Subject: Re: FW: EPA Confirmatory Testing D4 3.0 TDI CW43: weights + flight dates

Sent Subj attm	
Hello	Lynn,
Pleas syste	se find attached a revised document with improved diagrams to describe the Jetta Hybrid ORVR em.
	dition, I have attached answers to some of the questions we discussed. If you have any further tions, please let me know. If needed I can try set up a conference call to resolve any details.
Rega	rds,
Mike	
Q1	Page 2, Filling Ventilation:

Filling Ventilation:

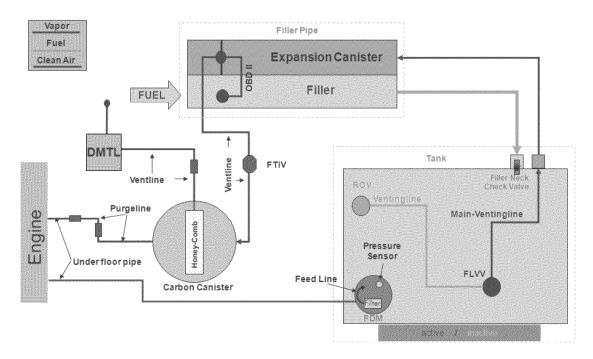
a)	Arrow direction seems wrong in the connection between DMTL to canister. (corrected in new file)
b)	Please clarify in drawing. (corrected in new file)
Q2 clarif	If engine is off, there are arrows from Canister and fuel tank to the engine – please confirm / iy if these connections are present (open) during the fill. (corrected in new file)
Q3:	Operation Ventilation Diagram (pg 3)

In none of the diagrams is gasoline shown entering the fuel tank. I would suggest adding an arrow indicating fuel going into the fuel tank in the "Filling Ventilation" figure.

In none of the diagrams is gasoline shown entering the fuel tank. I would suggest adding an arrow indicating fuel going into the fuel tank in the "Filling Ventilation" figure.

Operation Ventilation:

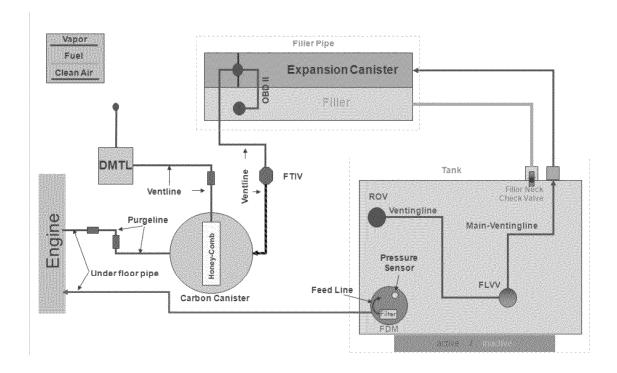
It also helps to know that, for the most part the FTIV is closed except in the case of refueling, for diagnostic purposes or in the event of critical pressure in the fuel tank. With that understanding, however, I wonder whether the same section of vent line shown as hashed in the "Regeneration" figure should also be hashed in the "Operation Mode"

figure. I think the same conditions would apply.

Regeneration:

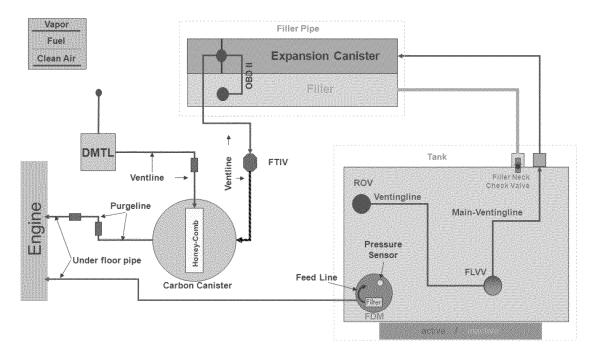
Q6: For the diagrams, please describe the yellow, black and mixed lines in the keys (for example in Regeneration, the line between FTIR and Carbon canister). (add for the broken line in new file)

In the answer to Q4, b) in your e-mail, you asked whether tank de-pressurization occurs during the Regeneration phase. The answer is "Yes!" but this contradicts the description of the regeneration phase.

According to the write-up, depressurization takes part during the "Filling Ventilation" phase. Is this correct?
